Staff Report

Infill Housing Design Review Committee

File Number: 11-D-20-IH

Location: 259 Cedar Ave. **Parcel ID** 81 B F 014
Zoning: RN-2 (Single-Family Residential Neighborhood)
District: Oakwood/Lincoln Park Infill Housing Overlay District

SITE PLAN

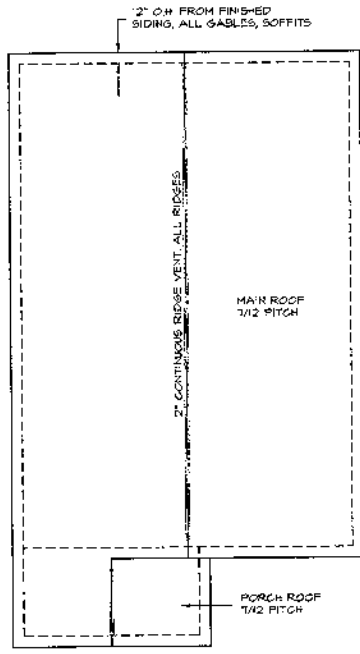
1. The block to receive the proposed new residence is populated mainly by Minimal Traditionals and contemporary infill construction. Houses on the east end of this block are set back significantly from the street. The front setback is proposed at 36.4' from the porch to the property line, and 44.4' from the primary house to the property line. While the minimum front setback for this block is 20', the two adjacent properties are set significantly back from the street (251 Cedar Ave at approximately 38' and 263 Cedar Ave at approximately 35.6'). Moving the house up slightly so the main house (instead of the porch) is in line with the adjacent houses will create consistent front yard spaces.

2. Placement of the house, including side and rear setbacks, is appropriate. The site design should incorporate a walkway from the front door to the street, running perpendicular to the street.

4. The proposal includes parking off the alley, with the parking pad located behind the proposed house. Guidelines recommend landscaping or fencing to screen alley-oriented parking pads. Parking should meet City Engineering standards. City Engineering has noted that while the site plan shows a new driveway from the alley, KGIS indicates an existing driveway from Cedar Avenue, and the site plan must be updated to show the existing driveway or add a note to the plans saying it will be removed.

- 1) modify front setback to place main house between 36' and 38' from the front property line;
- 2) install a walkway from the street to the front door;
- 3) omit decorative shutters on façade and vertical vinyl siding on porch gable;
- 4) substitute brick veneer for stone veneer on porch piers to better fit historic designs;
- 5) parking pad to be screened with landscaping or fencing and meet City Engineering standards.

FRONT ELEVATION
SCALE: 1/4" = 1'-0"

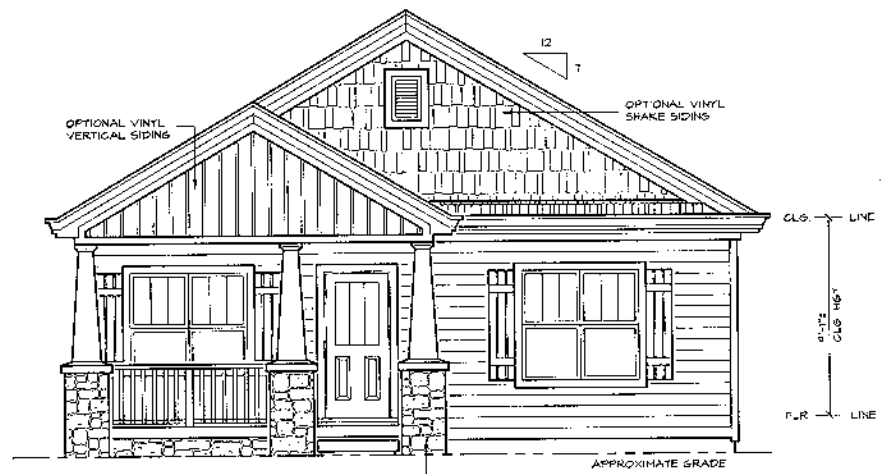
5. The 8' deep porch is appropriate under the design guidelines. Stone veneer is not a common historic material in Knoxville on porch detailing; brick piers are more appropriate under the Craftsman style. Windows and doors meet design guidelines. One additional window on the right side elevation would contribute additional transparency to the ratio of solid to voids.
